Wisconsin Electric POWER COMPANY
231 W. MICHIGAN, P.O. BOX 2046, MILWAUKEE, WI 53201

January 3, 1979

DOCKET NOS. 50-266 AND 50-301
ADDITIONAL INFORMATION
SPENT FUEL STORAGE EXPANSION
POINT BEACH NUCLEAR PLANT, UNITS 1 AND 2

Enclosed are responses to your requests for additional information which were forwarded to us with your letter dated December 6, 1978. We have designated this set of requests set "D" and have numbered the responses to match the respective information requests in your letter.

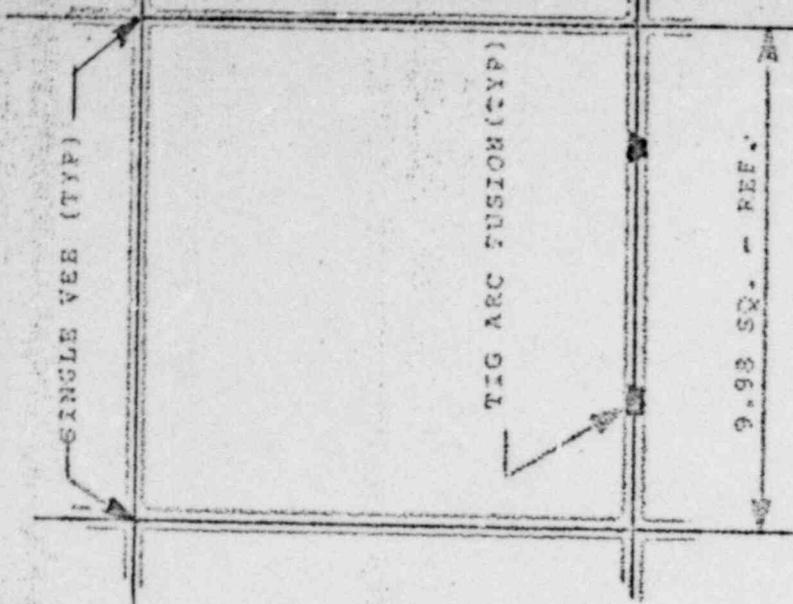
The October 10, 1978, response to question C-13 regarding drop of a fuel bundle directly into a storage position assumes that the maximum load which can be transferred to the bottom plate is equal to the Euler buckling load of the fuel bundle. This approach is incorrect in that a buckled column can continue to transfer load in its deflected shape. Furthermore, the buckling load of the fuel bundle has been incorrectly calculated since the bundle treated as a whole will have a higher buckling load than the sum of the individual rod's buckling loads. The integrity of the bottom plate should be re-analyzed using a correct approach such as an energy transfer mechanism.

Calculations which determined the integrity of a storage box when subjected to a straight drop of a fuel assembly were made to determine order of magnitude loading. The actual velocity of impact is indeterminate because energy dissipation at entry and down through the box are unknown quantities. The value used is considered a good estimate. A straight line of descent was assumed even though it is highly probable that the fuel assembly, which is definitely not hydrodynamically stable, will deviate considerably from a straight line and bump from side to side. Because of this extremely conservative approach the order of magnitude loading value is considered to be the column buckling of the fuel rods, used on the shortest grid-to-grid span. Any calculational refinement of the simple method used is of dubious value. As the bottom plate weld strength is shown to be about four times greater than the conservatively calculated buckling load, it is concluded that the box design is adequate.

MEP - POINT BEACH
TYPICAL WELD CONFIGURATION

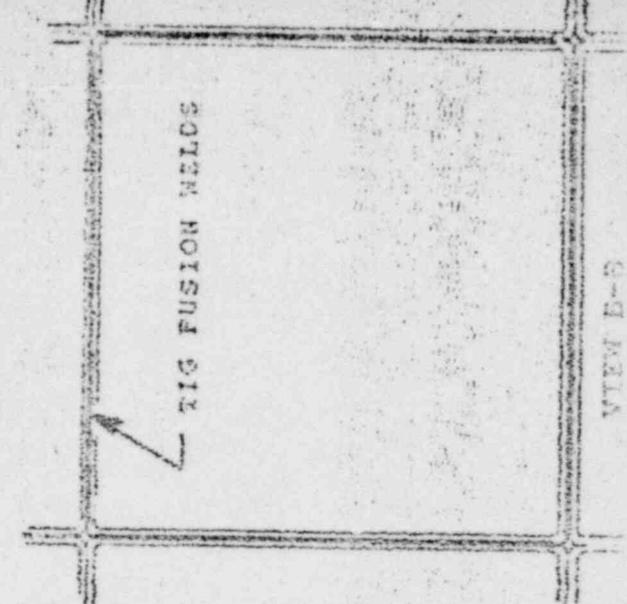
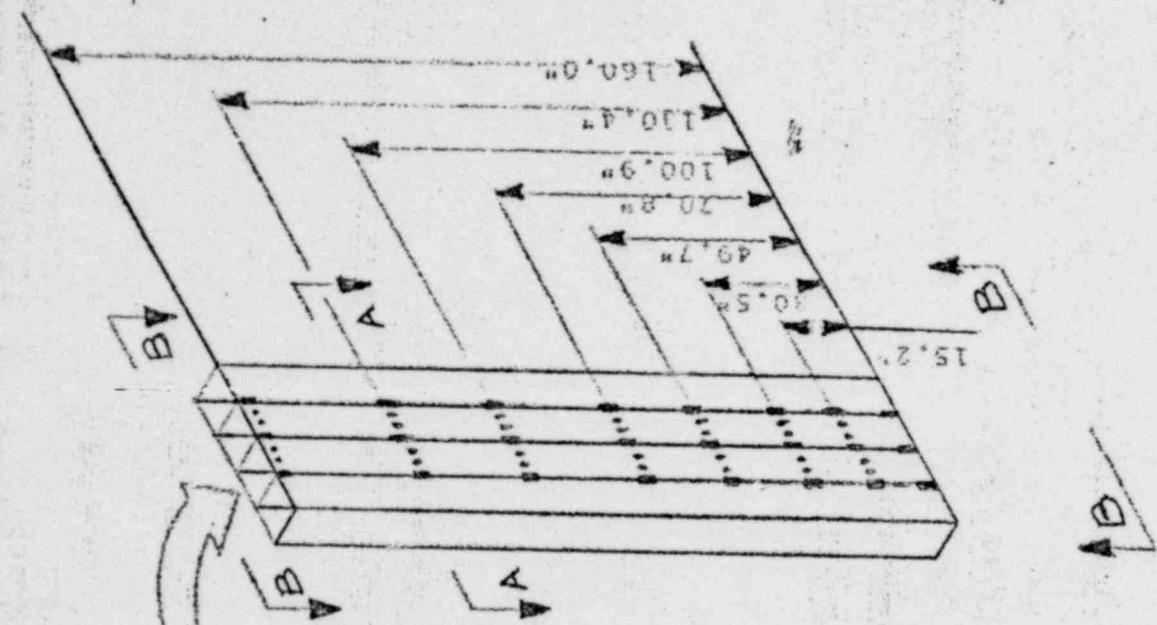
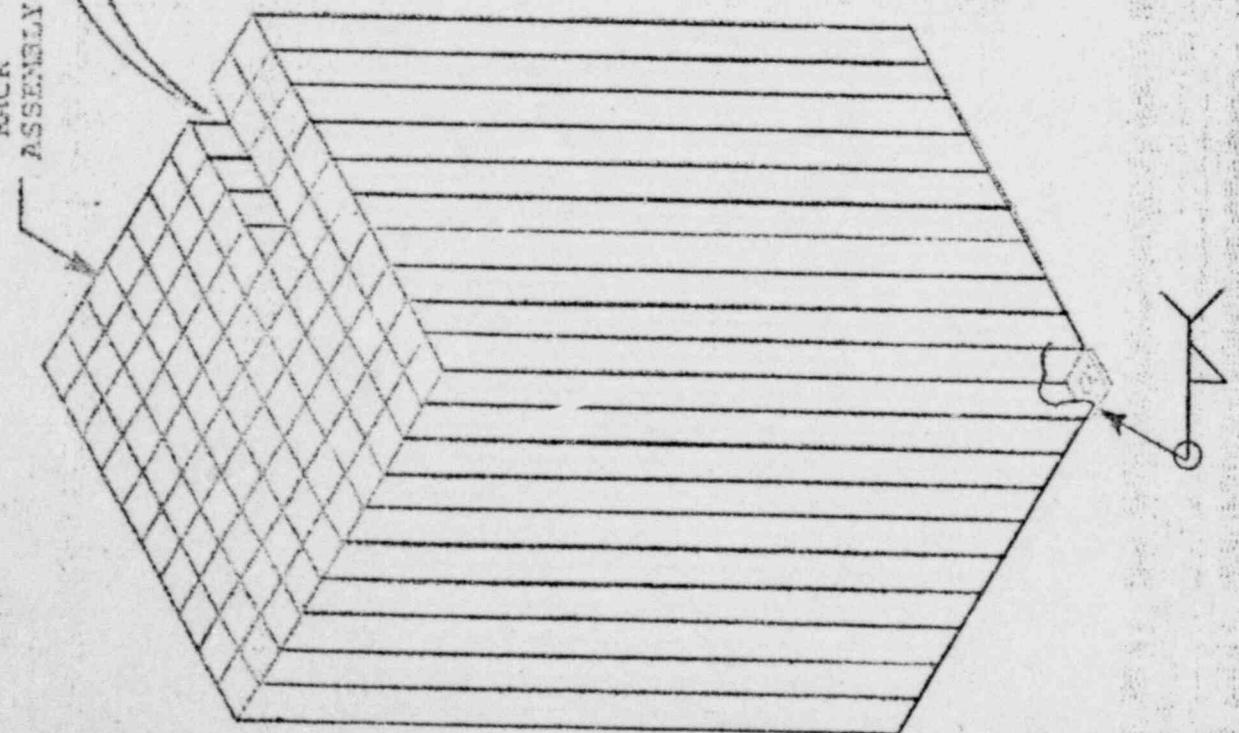
Provide sketches and describe the welds joining the individual fuel cells together. Discuss the welding procedures that will be used in fabrication of the racks and describe the quality assurance procedures.

Typical welding configuration for the Point Beach spent fuel racks is shown on the attached sketch. Boxes are welded into rows. Rows are stacked and fusion welded together as shown. Bottom plates are then welded into rack bottoms. Welding control is provided by weld technique sheets which contain welding parameters in accordance with welding qualifications which meet the requirements of Section IX of the ASME Boiler and Pressure Vessel Code and 10 CFR 50 Appendix B. Quality Assurance procedures are in accordance with the WAI Quality Assurance Program Manuals and are documented on Route Cards utilized by U. S. Tool and Die which are signed off by WAI Quality Assurance after inspection of fabricated racks.

D-12-2

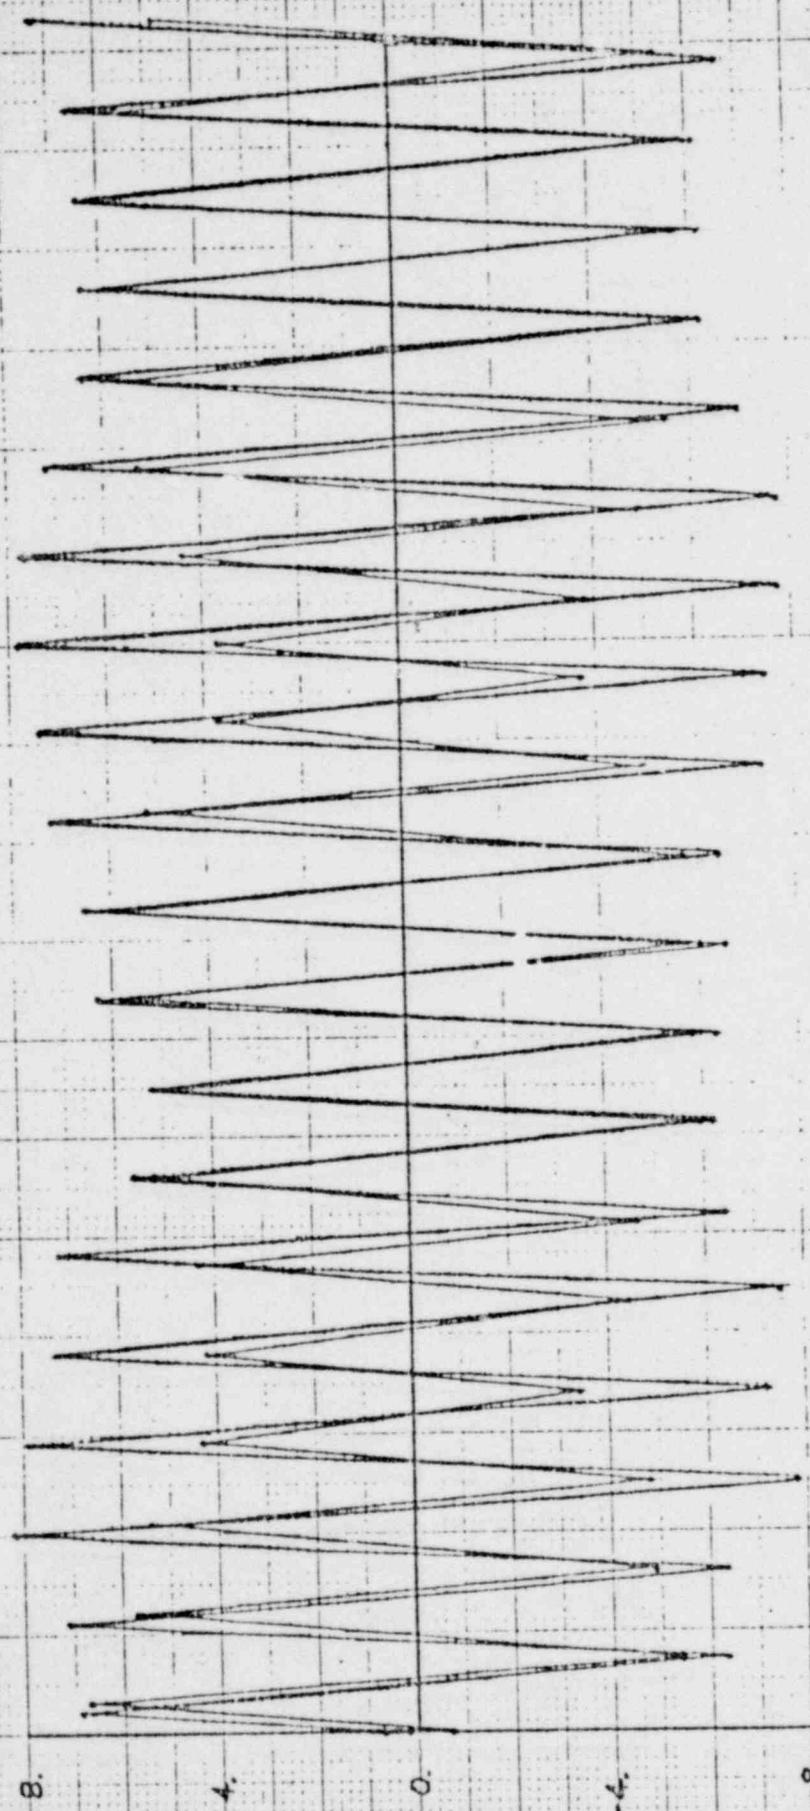
Describe the extent to which interaction between storage racks was analyzed including the modelling techniques and boundary conditions.

Interaction between two storage racks adjacent to each other was analyzed assuming that one rack was full and one rack empty. The racks were separated by a small gap and subject to the N-S 1940 El Centro time history motion. One full and one empty rack is the most severe dynamic mismatch and yet the calculated results show that the modules vibrate in phase as indicated on the attached graph. Vibrating in phase means no rack-to-rack impact. The graph does not differentiate between full and empty since the lines are so coincident that it is only academic to attempt identification which would be extremely difficult to follow.
